Transport Technical note

Project name	Northampton Station Redevelopment		
Technical note title	Consultation Feedback Response		
Document reference	16690-HYD-XX-XX-RP-TP-1002		
Author	Ben Smith-Laing CEng MEng(hons) MCIHT CMILT		
Revision	P02		
Date	10 October 2023	Approved	✓

1. Introduction

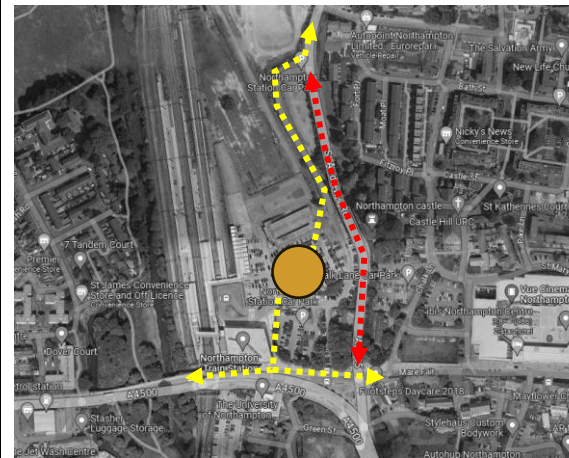
Stakeholder comment	Hydrock comment
<p>The eastern end of the cycle track also needs to lead directly to the cycle parking so that users do not have to dismount and push their bike through the site, and conversely are able to remount immediately from removing the bike from the cycle racks. This is especially important for those who rely on using a bicycle for mobility and who are otherwise limited in their movements. This will also help eliminate any potential conflict between users in the accessible car park area.</p>	<p>This has been amended in an updated layout plan, which is included as Appendix B of this note.</p> <p>Although the comments on potential for conflict between cyclists and users of the accessible car park area are noted, this car park is relatively small (12 spaces) and will be a lightly-used, very low speed area. Similarly, cyclists will be travelling at low speed, as this is a no through route. As a result, the risk of conflicts is considered to be very low.</p>

<p>Further to this, given that many users of the cycle parking facilities would be leaving their bikes for long periods of time, this would seem like a good opportunity to introduce a secure, undercover "bike-hub" type facility similar to the one recently introduced at Kettering Rail Station. This could include electric cycle charging points.</p>	<p>The cycle parking proposed accords with Network Rail requirements, and the operational needs of the London Northwestern Railway, the station operator.</p> <p>It maximises the space available in a well overlooked and convenient location of the site, providing covered cycle parking that is suitable for long stay users.</p> <p>London Northwestern Railway will monitor the use of the cycle parking to ensure that it remains fit for purpose, and meets the requirements of their customers.</p>
